ROADWAY CONSTRUCTION

INTERSTATE ROUTE H-1
PROJECT NO. I-IR-HI-1(169):17

SCALE: 1" = 50' DATE: 3/15/82
SHEET No. C-1 OF 17 SHEETS

"AS-BUILT"

SHEET No. C-3 OF 17 SHEETS

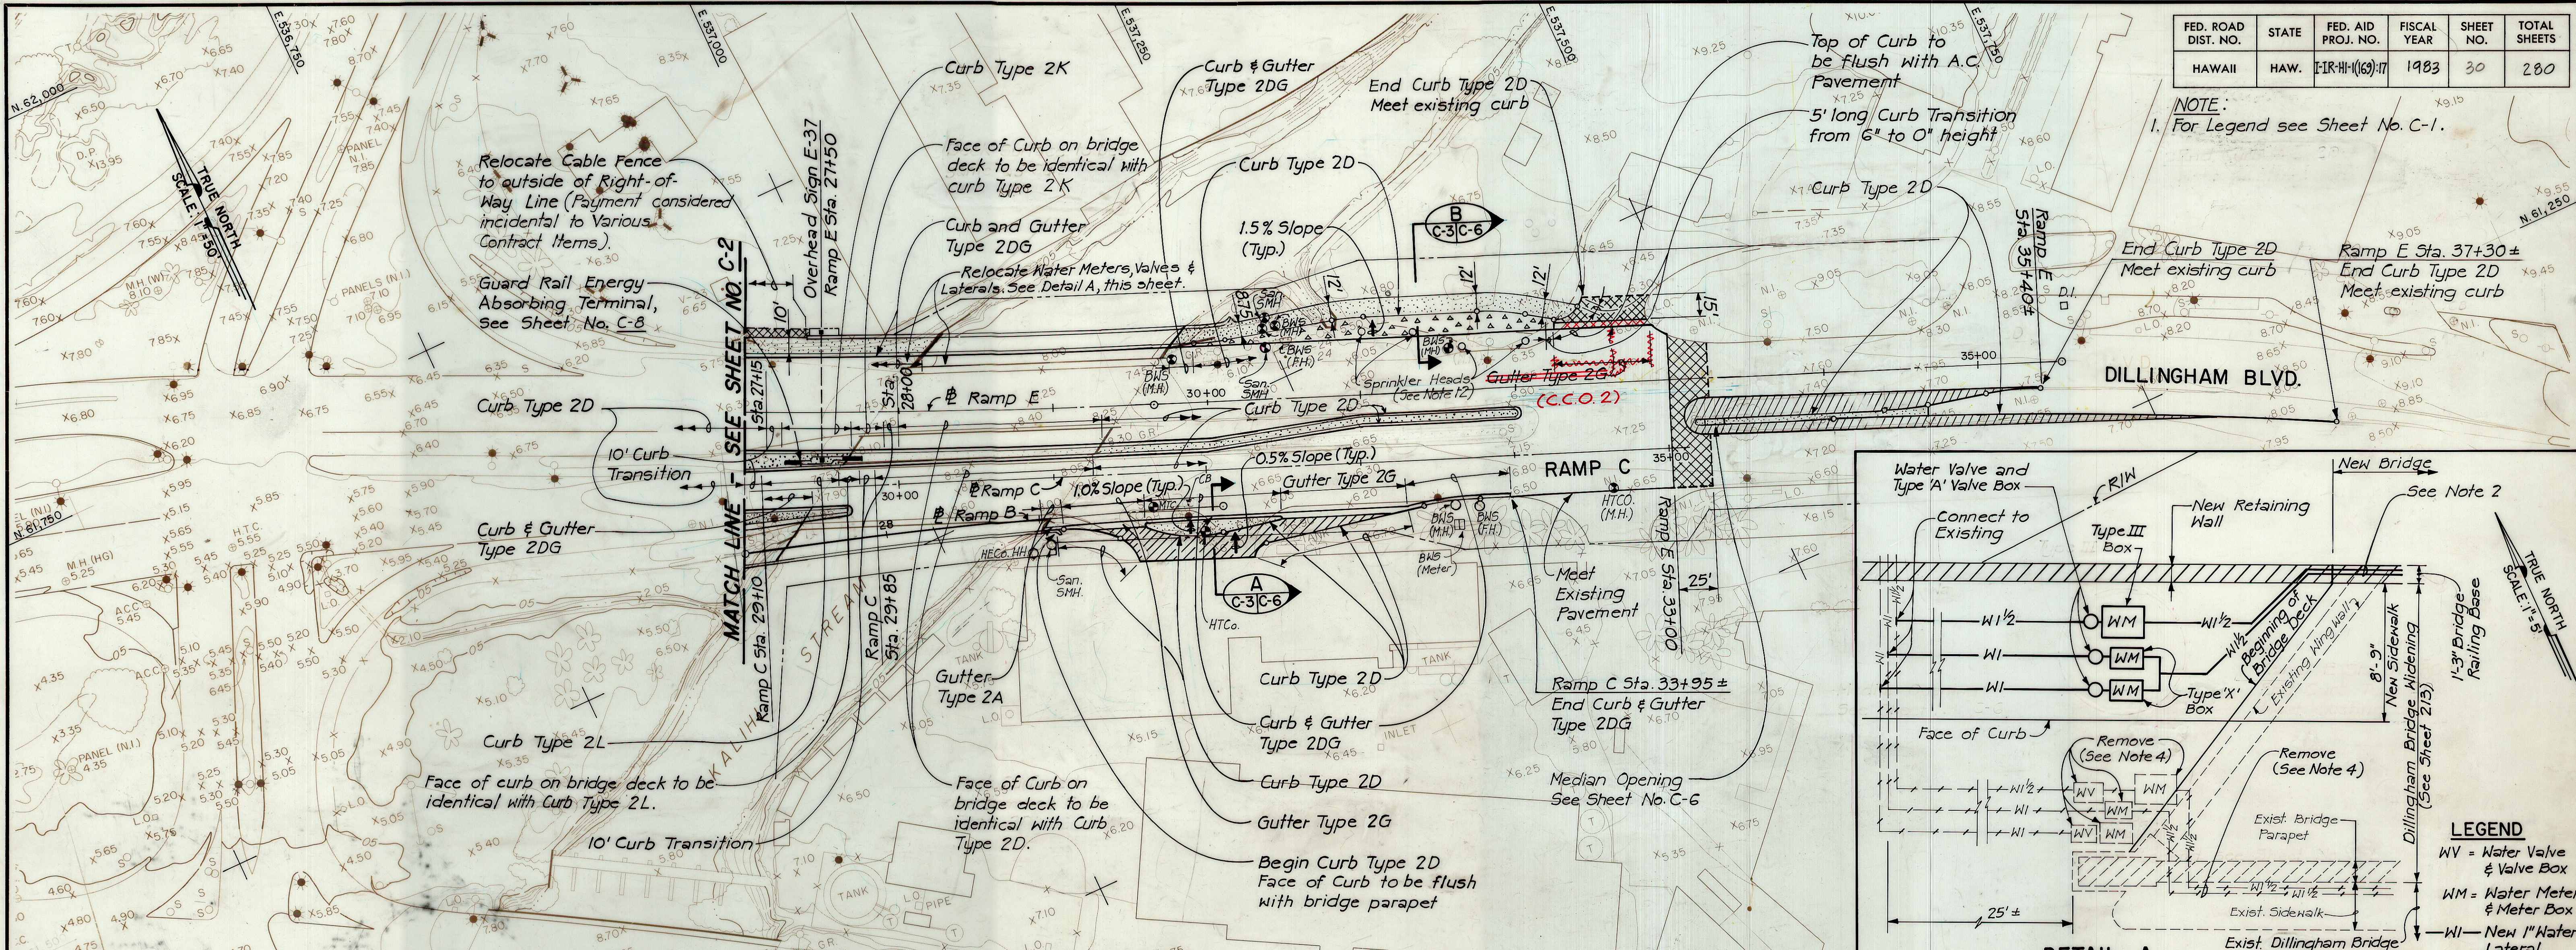
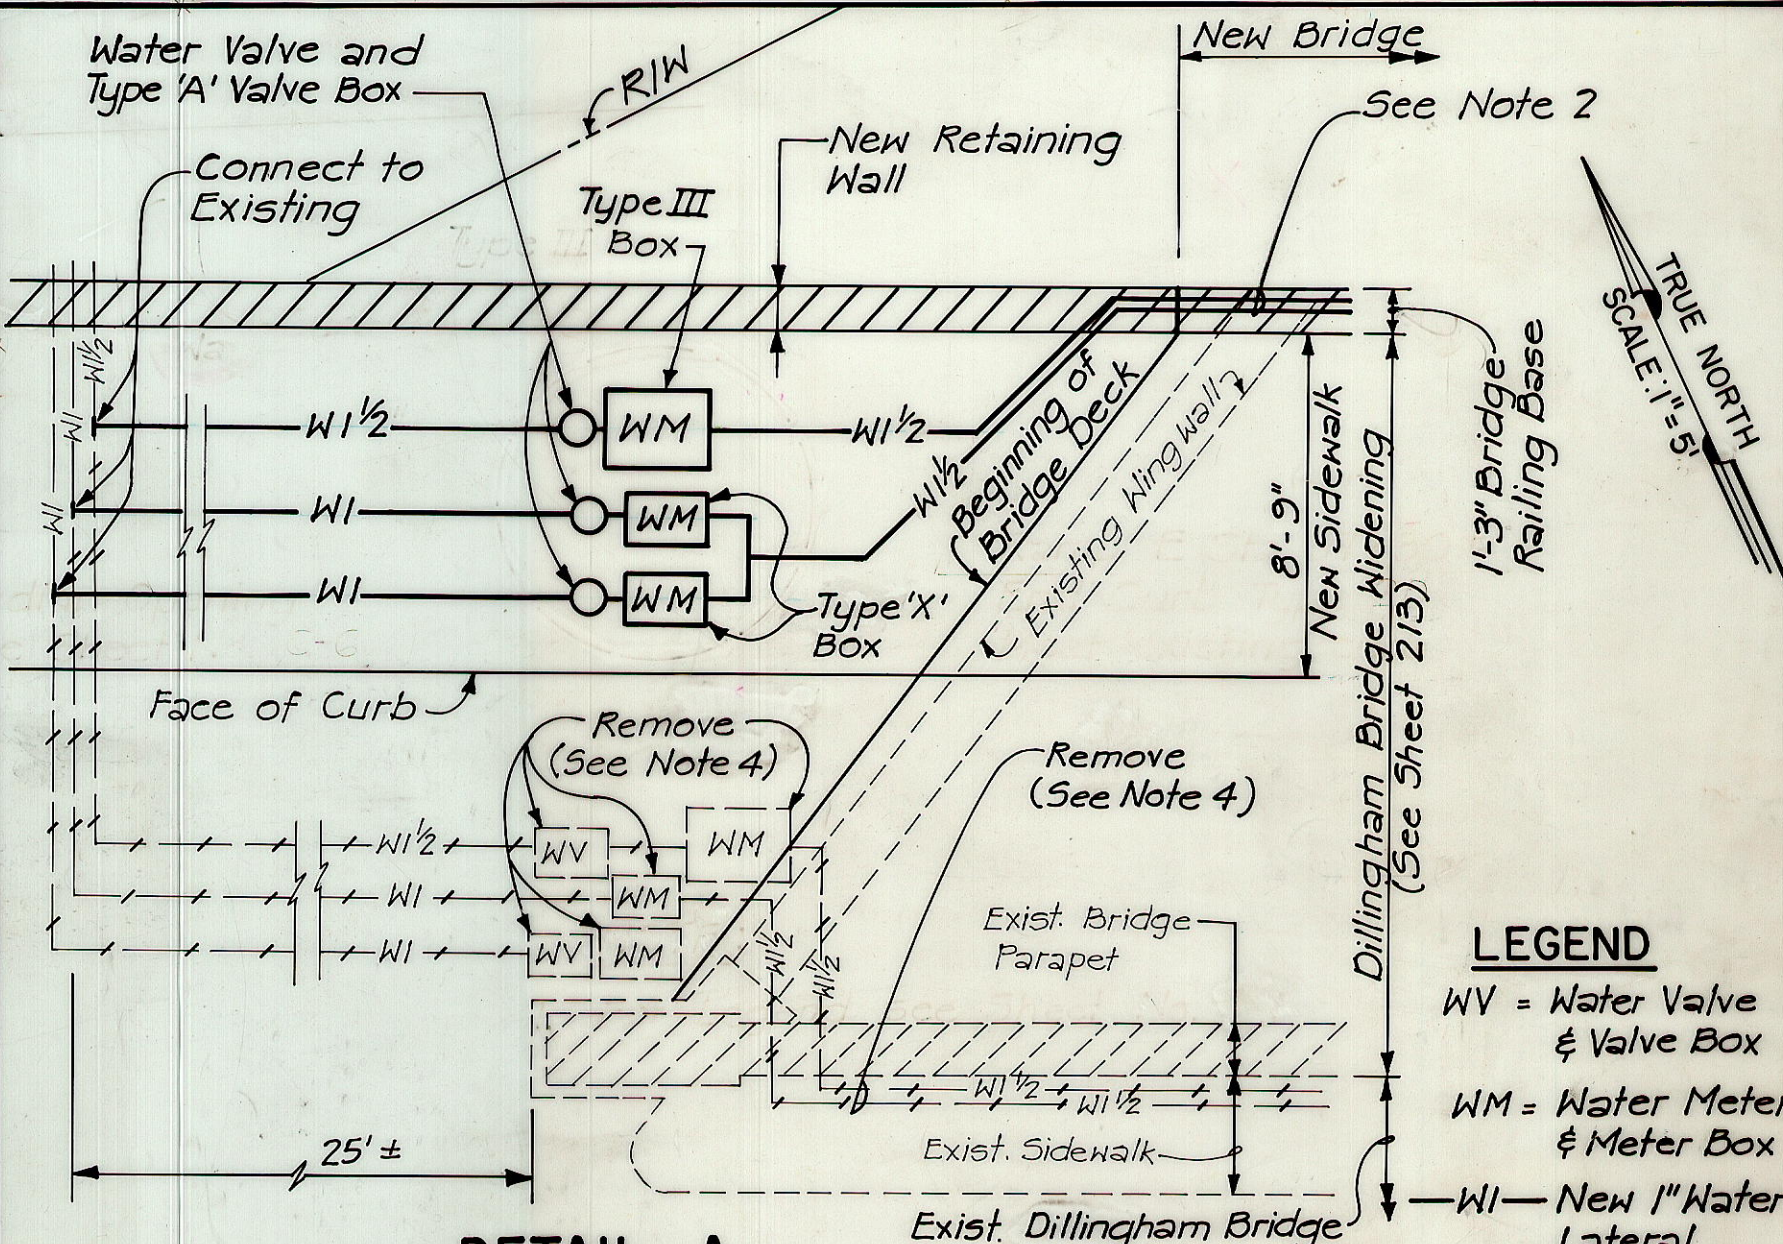
2/5/86	Install Left Turn Median Lane Ramp E Sta. 30+00 to 32+00
5/19/89	Detail A added.
DATE	REVISIONS
